SCHWEIZER SERVICE NOTICE

NOTICE NO. N-120

SUBJECT: WIRING MODIFICATION - INTEGRATED DUAL COMMUNICATION
CONSOLE (ATI)

MODELS AFFECTED: Model 269C Helicopter Serial No. 0190 and Subsequent
equipped with both Searchlight Kit and Integrated
Communications Kit (Policepac)

Figure 1. Wiring Modification - Integrated Dual Communications Console (ATI)

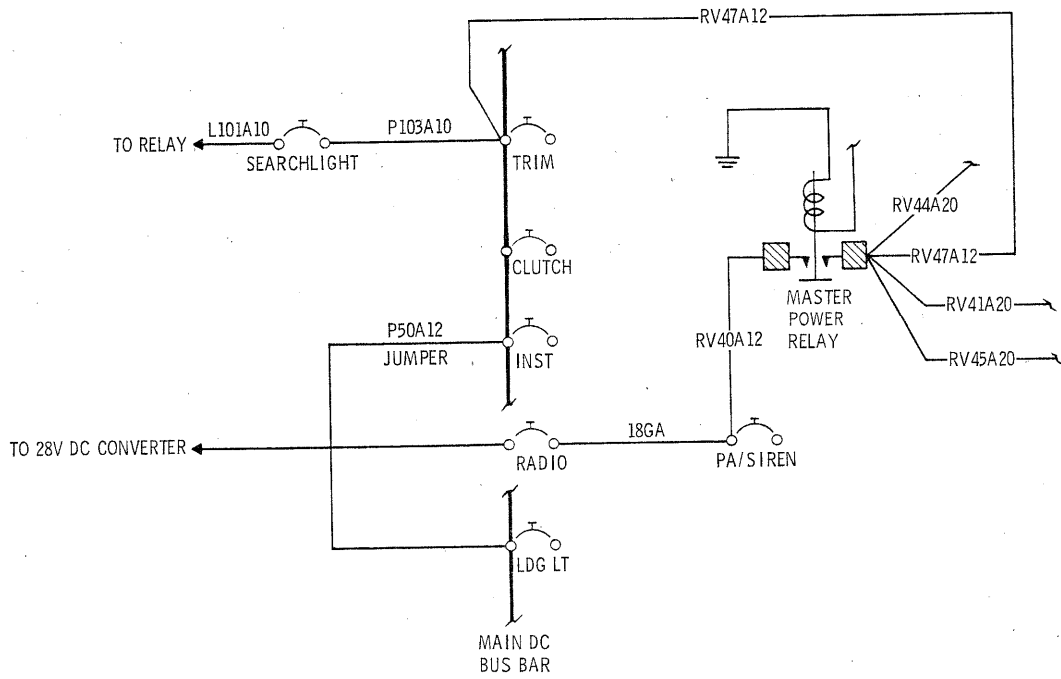
If 18GA wire is presently installed, replace with new 12GA wire (P50A12) as shown in Figure 1.

- d. Disconnect existing 12GA wire (RV47A12) from HEATER circuit breaker at main bus bar. Reconnect to TRIM circuit breaker at main bus bar as shown in Figure 1. Install new 12GA wire if length of existing wire No. RV47A12 is not sufficient.
- e. Check that existing 10GA wire (P103A10) from SEARCHLIGHT circuit breaker to main bus bar is connected to TRIM circuit breaker at main bus bar as shown. Install new 10GA wire if not installed as shown and length of existing wire No. P103A10 is not sufficient.
- f. Perform operational check of searchlight, landing light, and integrated communications systems.
- g. Reinstall panel fairing.
- h. Record compliance with this Service Information Notice in Compliance Record of helicopter Log Book.
